# PARTS & SERVICE NEWS

REF NO.	AT03214
DATE	Nov. 10, 2003
(C)	Page 1 of 4

**SUBJECT:** REPAIR PROCEDURE OF LEANING ROD

**PURPOSE:** To introduce modification procedure to repair the deformed leaning rod

Fig. 1

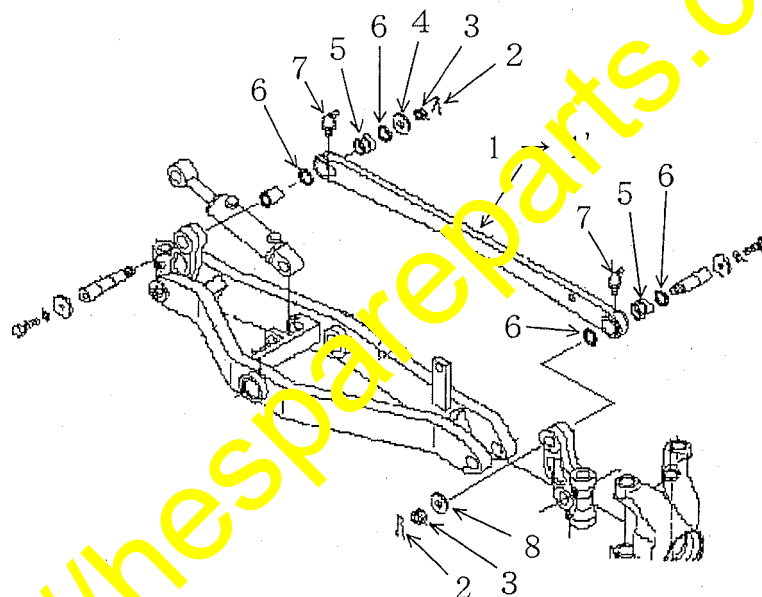
Replace the leaning rod with the improved parts (with increased rigidity).

(1) Remove the cotter pin (2) on both ends of the leaning rod (1) and remove the nuts (3) and washers (4), (8).

(2) Remove the leaning rod (1) with the bushing (5) and the seal (6) installed.

(3) Install the newly arranged improved leaning rod (1') in the reversed procedure to the removal procedure. (Refer to the Table 1 for the part numbers.)

Fig. 2

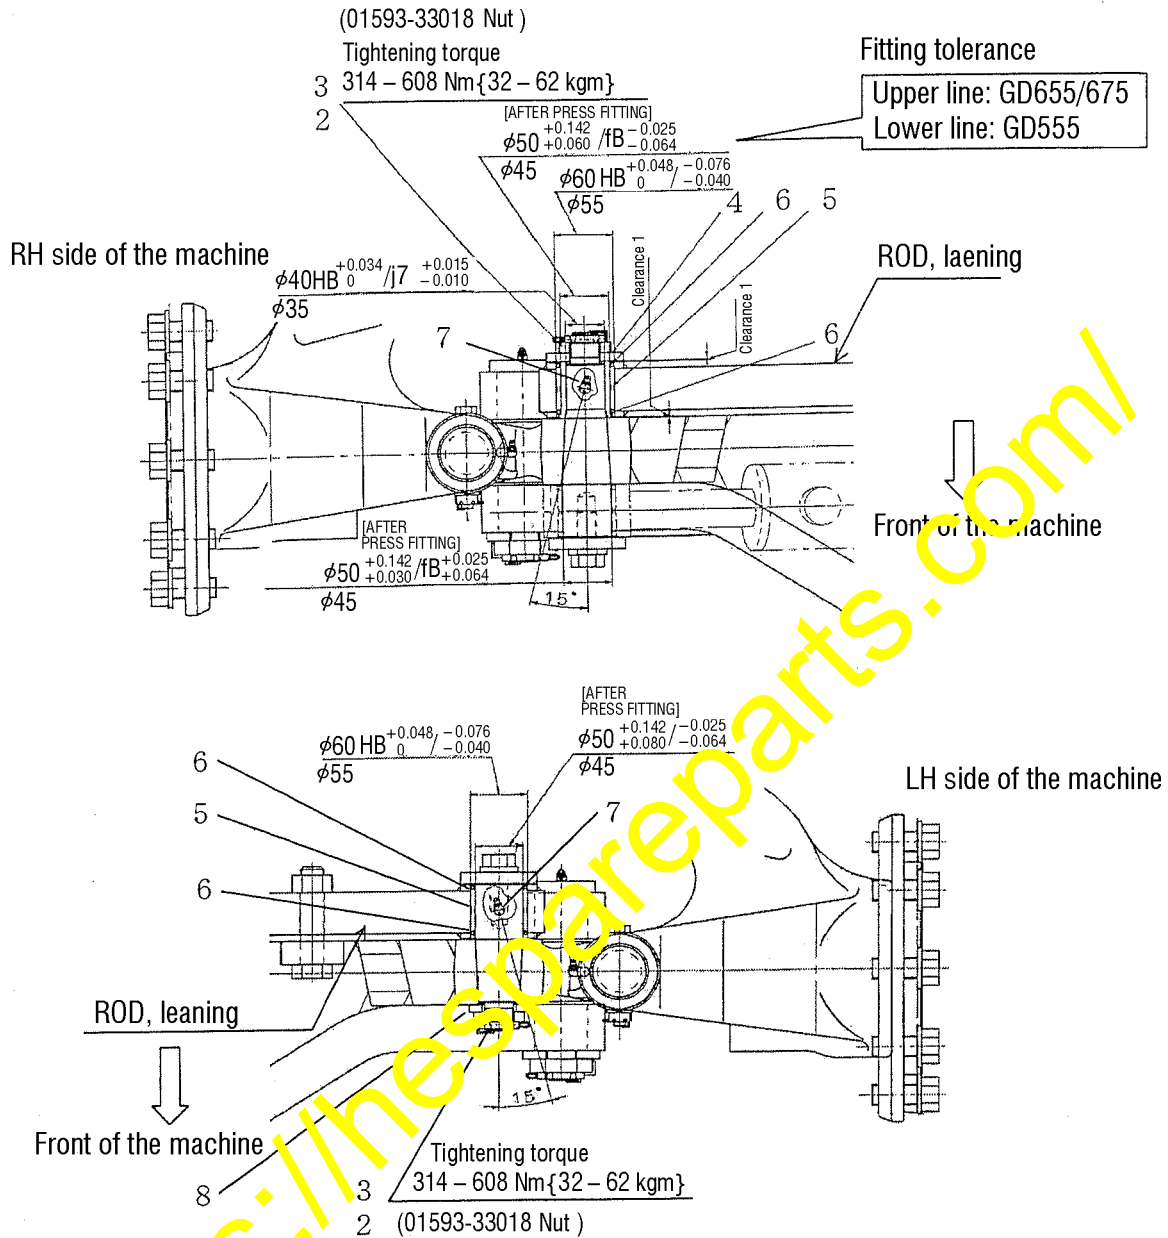
- Reuse the grease fitting (7) and regarding the direction of installation, refer to Fig. 2.
- Replace the bushing (5), seal (6) and cotter pin with the new parts when carrying out the reinstallation work for the leaning rod. (Part numbers are the same.)
- Refer to Fig. 2 regarding the tightening torque for the nut (3).
- Refer to Fig. 3 regarding the installation procedure for the seal (6).

Tightening torque for the nuts

Fig. 3

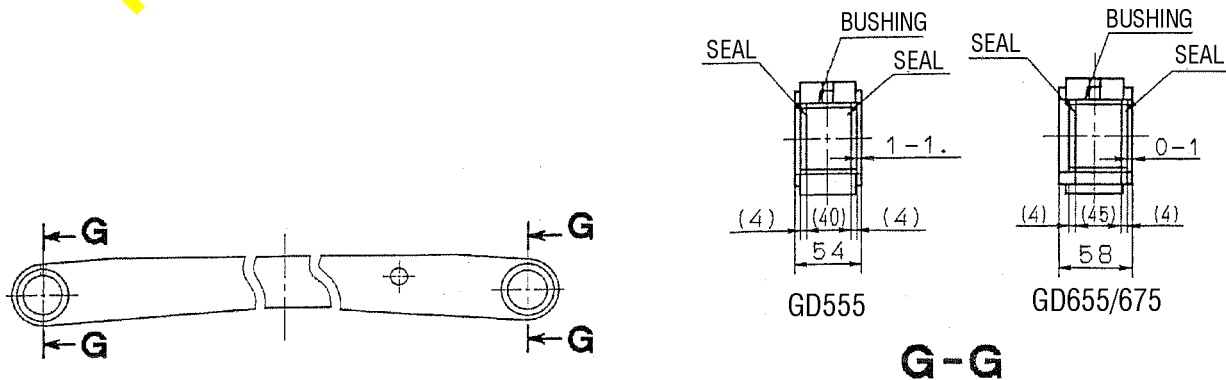
Install the dust seal referring to Fig. 3 shown below.

Apply sufficient quantity of G2-LI to each seal lip before inserting into the shaft.
